Thor Motor Coach Recall Repair Instructions

Recall #	25V-792 2025-635		
Description/Title:	Flexible Solar Panel		
Affected Product Line(s):	Certain MY 2022-24 Tellaro, 2023-24 Scope, Sequence, Rize, and Dazzle, 2024 Twist		
Service Campaign # :	RC000337		
Repair Code:	Inspect with Repair: TMCRC80506V	Document Date:	1/30/2026
Time Allowed:	Inspect with Repair: 1.0	Document Revision:	A

TIP1336:

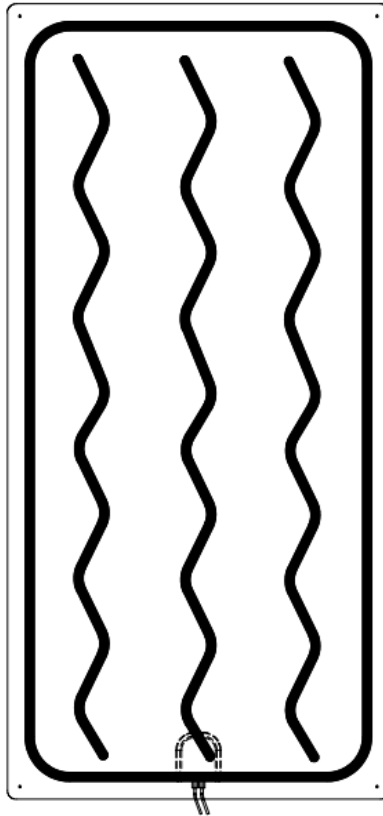
It has been discovered that the solar panel may not have sufficient adhesive allowing the solar panel to become loose and/or detach during transit.

1. Remove the Sikaflex 295 UV adhesive from the solar panel.
 - a. Testing has shown the adhesive should remove easily and may be peeled off.
2. Once the solar panel has been lifted off the roof, do not remove or replace the 3M tape on the solar panel.

3. Remove the Sikaflex 295 UV adhesive from the Skybunk pop top roof.
 - a. The adhesive bonds well to the pop top and should be carefully cut down as thin as possible; approximately 1/16” remaining on the surface.

4. Clean the pop top and solar panel with alcohol and follow the procedure outlined in TIP1336
 - a. Ensure the new Sikaflex 252 adhesive is **not applied over** any remaining 295 UV adhesive or 3M tape.

5. The screw grommet holes around perimeter of solar panel can be filled with the 252 Sikaflex to minimize water under the solar panel.
- 6. After reinstalling the solar panel, do not drive the unit for a minimum of 12 hours to allow initial adhesive curing.**

- APPLY A 1/4" TALL TRIANGULAR BEAD OF SIKA 252 AROUND THE OUTER EDGE OF THE BACK OF THE SOLAR PANEL
- APPLY A 1/4" TALL TRIANGULAR BEAD OF SIKA 252 IN A WAVEY PATTERN
- CENTER AND ALIGN THE SOLAR PANEL WITH THE BACK EDGE OF THE SKY BUNK
- THE SOLAR PANEL NEEDS TO BE FIRMLY PRESSED DOWN
- AFTER SOLAR PANEL IS INSTALLED, APPLY A 1/4" BEAD OF SIKA 252 AND SMOOTH OUT ALL THE WAY AROUND THE OUTER EDGE OF THE TOP OF THE SOLAR PANEL
